Section 92 response to further information request for Notice of Requirement – Whenuapai Wastewater Servicing Scheme Package 1

Attachment 1 - Section 92 Request for Information: BUN60422958

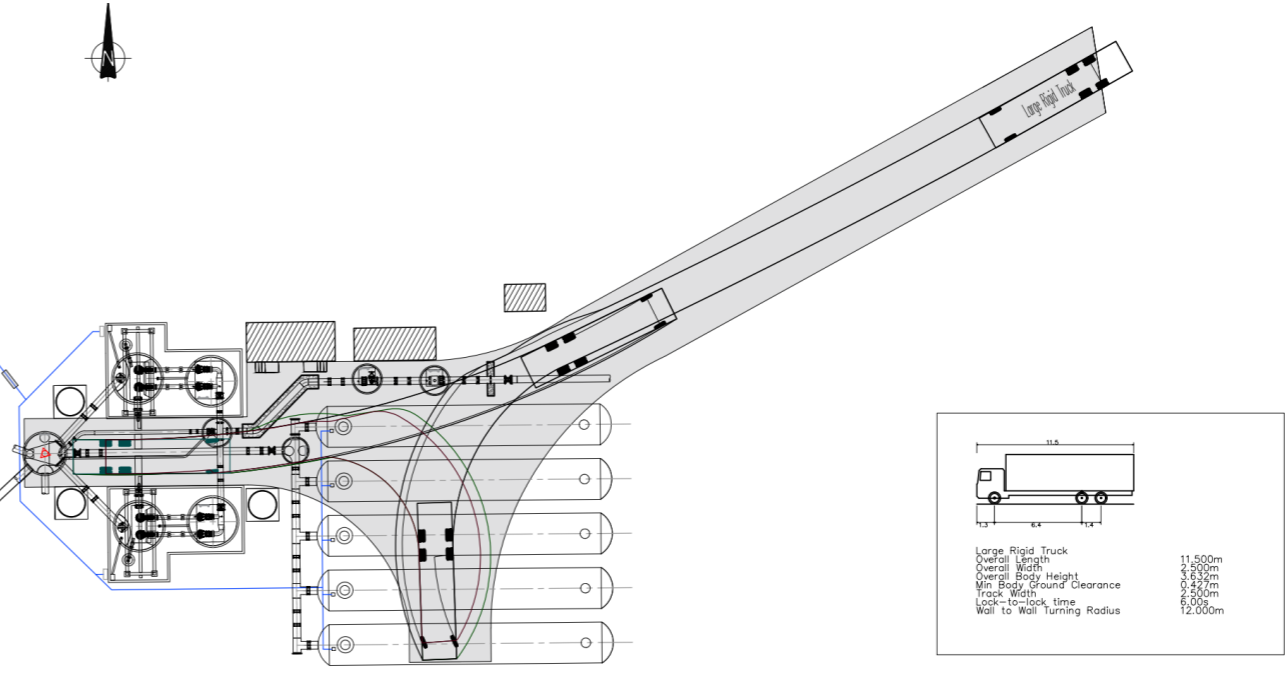
TRA1	Please provide further detail on the parameters used/assumptions made on the stop-go operation on SIDRA and the phasing summary of the SIDRA outputs.	Attachment 2 provides the phasing summaries for the NORMAL and CHRISTMAS scenarios for the stop-go operation. We allowed for a maximum of 150secs for the 'Practical Cycle Time' setting to run the model. A yellow time setting of 2 seconds and all-red time setting of 15 seconds was input based on the length of the stop-go operation.
------	---	---

Figure 3: Sight distance west at the Spedding Rd / Mamari Rd intersection (sight distance calculation lines in black, vegetation clearance extent between black and orange lines)

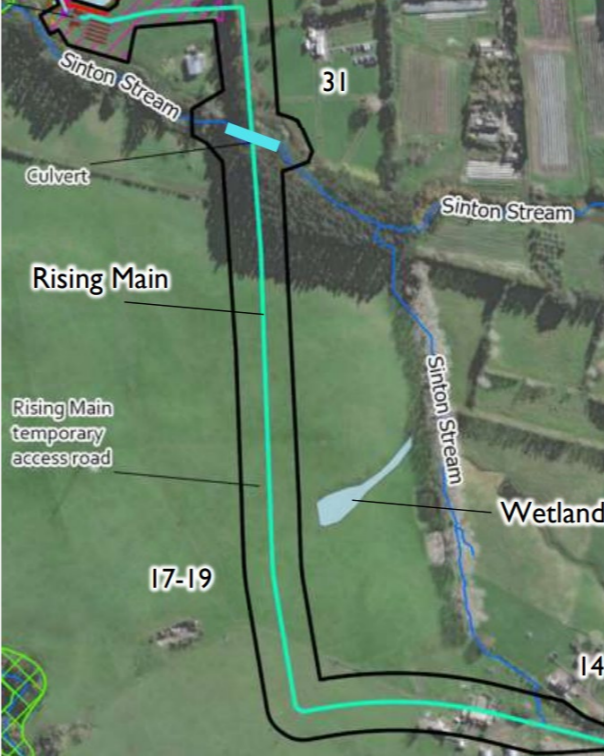
TRA 4	Please provide sight distance drawings at each of the SAPs and key intersections identified. The visibility assessment should consider both the horizontal and vertical alignment.	<p>High-level detail for each of the access sites has been provided in Section 5 of the Transport Impact Assessment. Most of the changes required involve vegetation removal along property boundaries or temporary speed management to reduce the required sight distance where other measures are not possible.</p> <p>SAP 4 does not meet the requirements for the sight distance given its location in a medium density residential development and is a low volume type road. However, this is considered acceptable because:</p>
-------	--	--

For the two intersections where visibility is obstructed (Trig Rd / Spedding Road, Spedding Rd / Mamari Rd) the following figures show what vegetation may need to be removed to provide the adequate sight distance. For Figure 2, Figure 4 and Figure 5 the black lines are the measures for the sight distance calculations and the area between the long black line and orange indicates what is expected to be cleared in order to provide adequate sight distance. For the purposes of clarity, trimming, alteration, or removal of trees on roads adjoining the future urban zone is a permitted activity under Rule E26.4.3.1 of the AUP.

The aerial photographs below do not show the extent of vegetation removal required and it will only be clear once on-site what is required to be removed to meet the sight distance requirements. These issues will be addressed as part of the Construction Traffic Management Plans which is required under Condition DC8, and which will be completed before construction begins.

PROP WW GRAVITY MAIN LONGITUDINAL SECTION

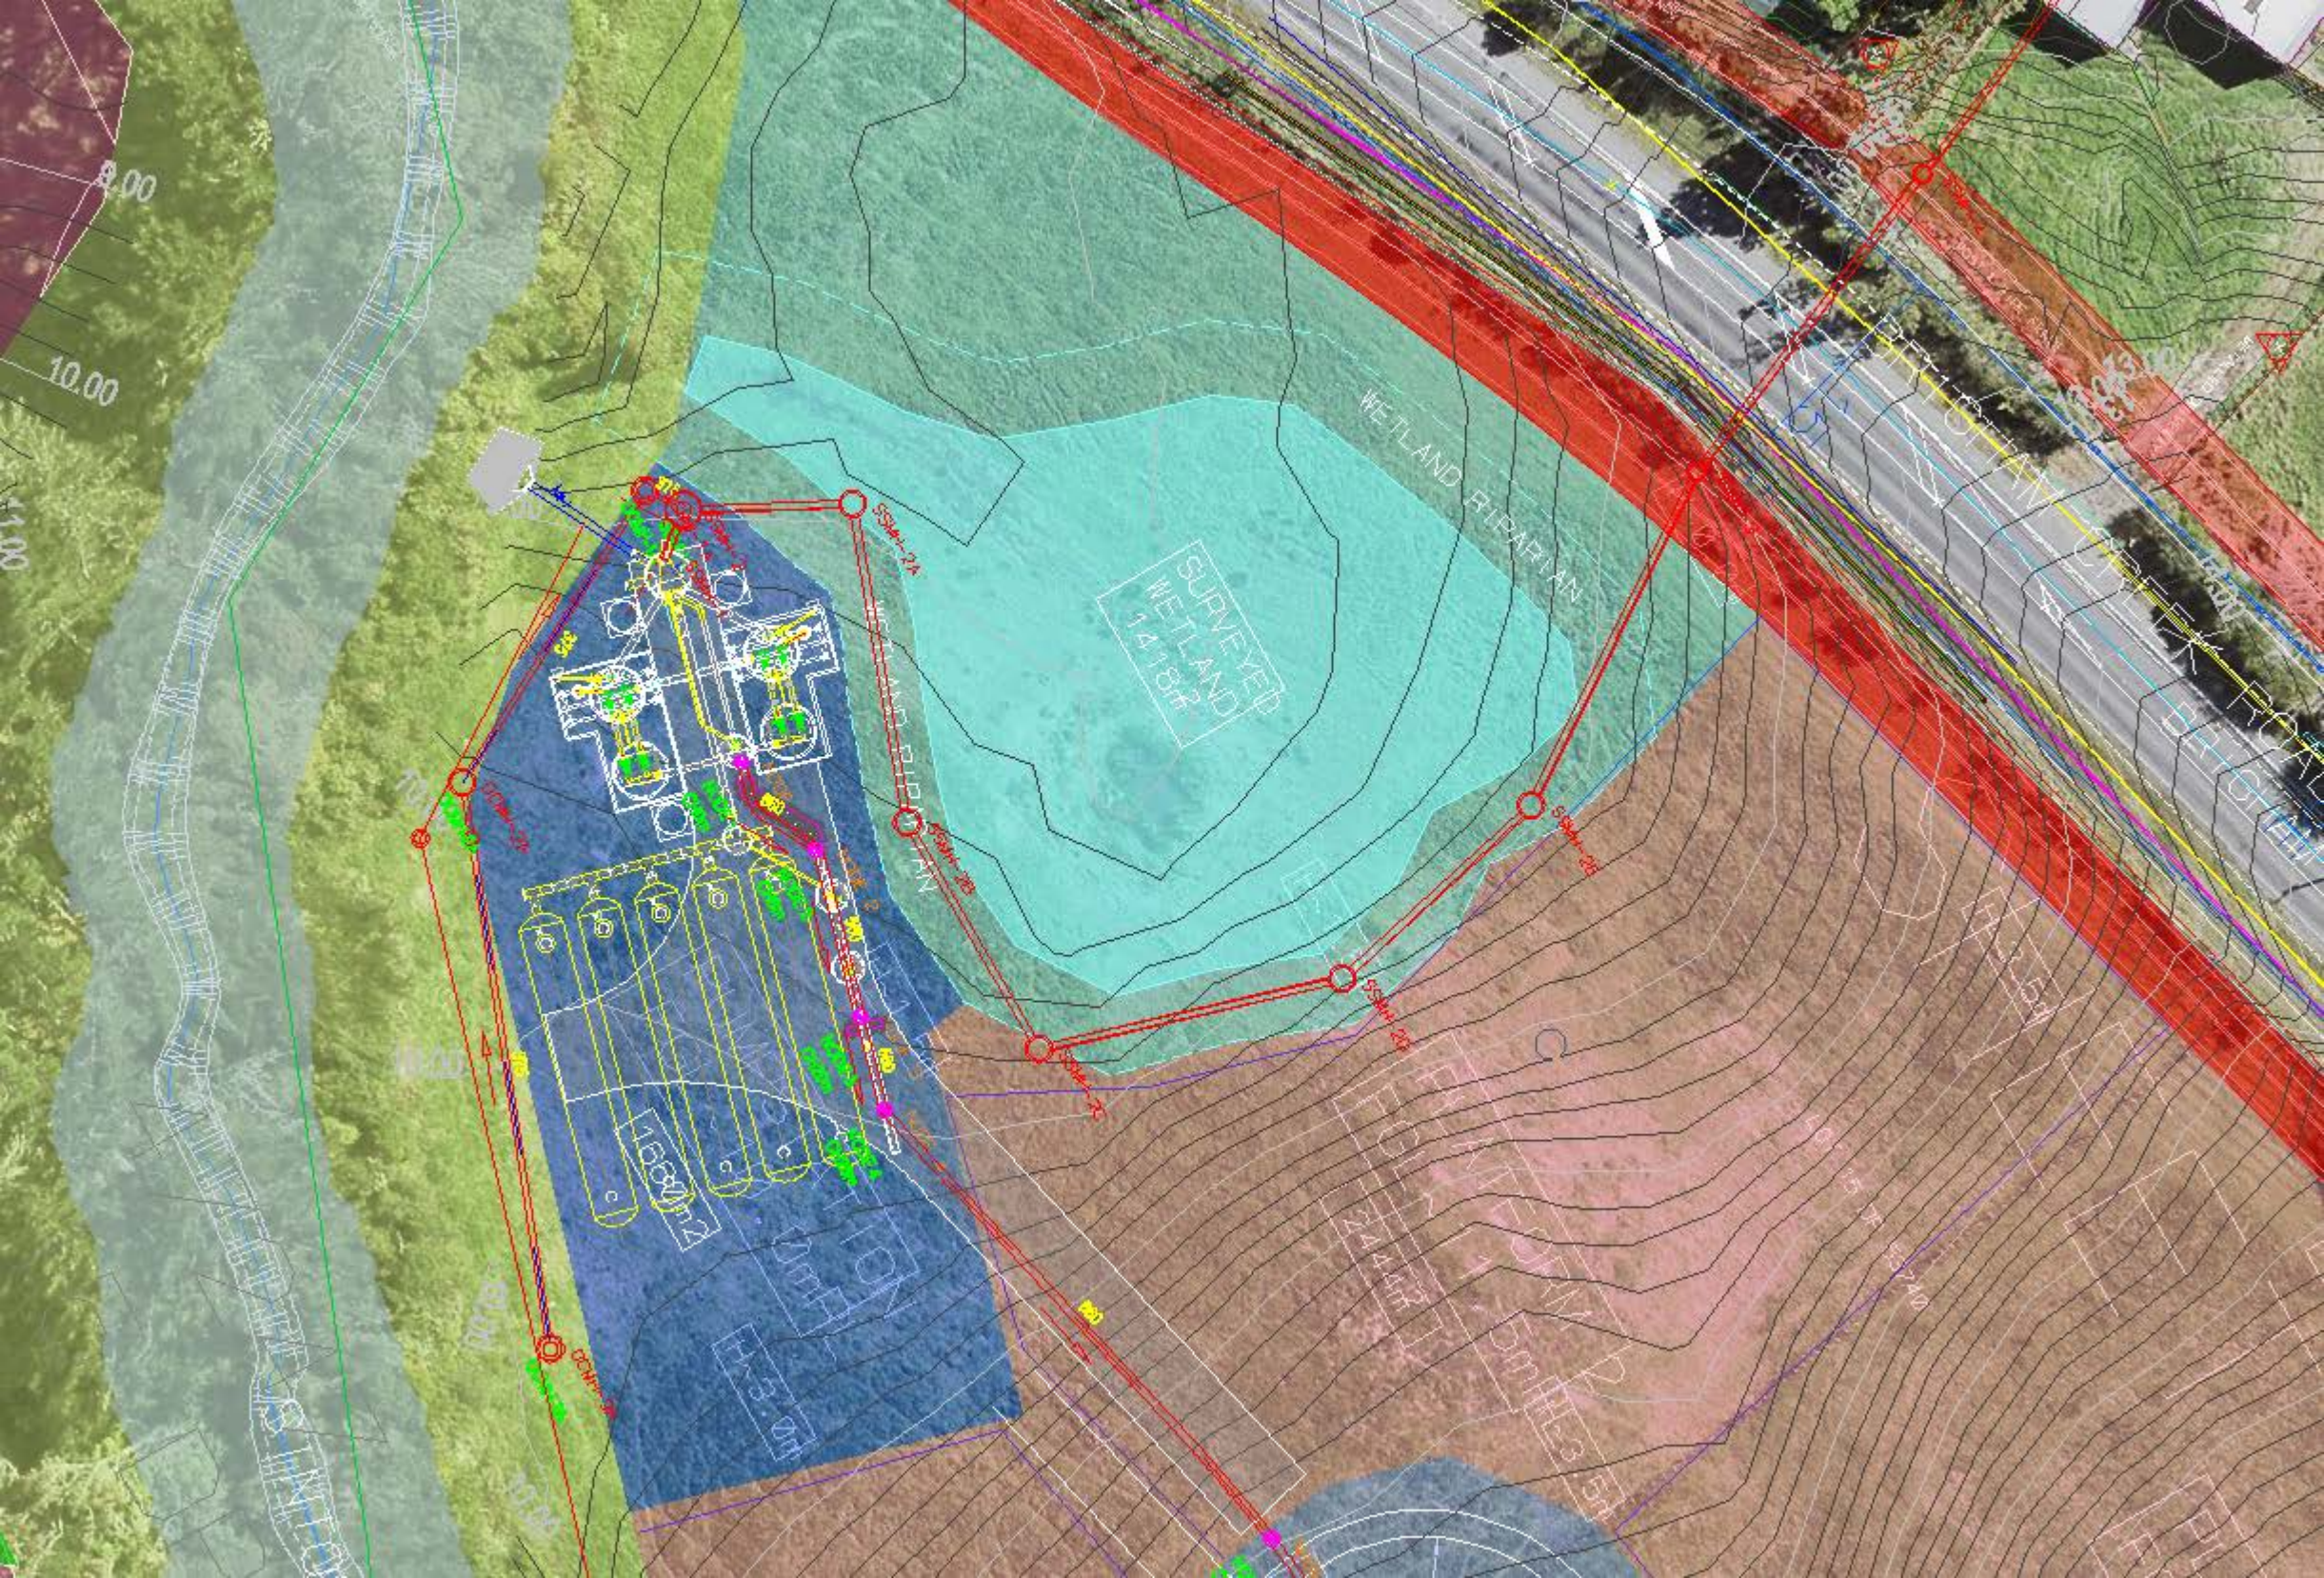
ENG 1 Can you please consider the comments above (*as included in Council's s92 request*), and reconsider the functional requirement for the location East of the wetland. Please include pipe route, including consideration of rearranging structures within the WSL pump station land in this assessment.

GHD have completed a 12d longsection design for the eastern route. A sketch and longsection are provided in **Attachment 3**.

<p>In order to maintain a similar pump station depth, the eastern route alignment along the wetland perimeter requires 5 additional manholes (ranging from 2.9-3.8m deep), and 50 m additional pipe length.</p> <p>As the pump station site is directly adjacent to the wetland riparian, it is inevitable for the eastern route alignment to run within the riparian margin to discharge at the inlet manhole. This is how the design is shown on the 12d sketch. Some of the upstream manholes could be moved outside the margin but will further increase depths and pipe length. On this basis, extending the gravity main to the eastern side of Wetland C is still considered to have an impact due to greater excavations, with associated greater environmental effects including increased drawdown of the wetland.</p> <p>Other information to consider on the route selection:</p> <ul style="list-style-type: none"> Proposed interim Slaughterhouse pump station has been sited on 23A Brigham Creek Road to serve development of land south of Brigham Creek Road. The pump station is at the lowest possible elevation providing for the most efficient hydraulic operation of the network, whilst being outside of Wetland C itself. The proposed position of the pump station enables the provision of an emergency overflow from the pump station to the stream. Wastewater from the current Whenuapai network is to be diverted from the existing WW pump station in Tamiro Road to the new proposed new interim Slaughterhouse wastewater pump station. The proposed new wastewater trunk sewer to the new pump station starts at the existing pump station with the upstream invert level set as high as possible whilst maintaining gravity flow from the existing network. The new trunk main generally follows the 100 year AEP flood level of the existing watercourse at minimum acceptable grade of 0.5% to maintain self cleansing flow. The route was optimised with consideration to various factors, including HSE, environment, and providing the minimum construction cost and time by minimising excavation depth for the proposed new pump station.
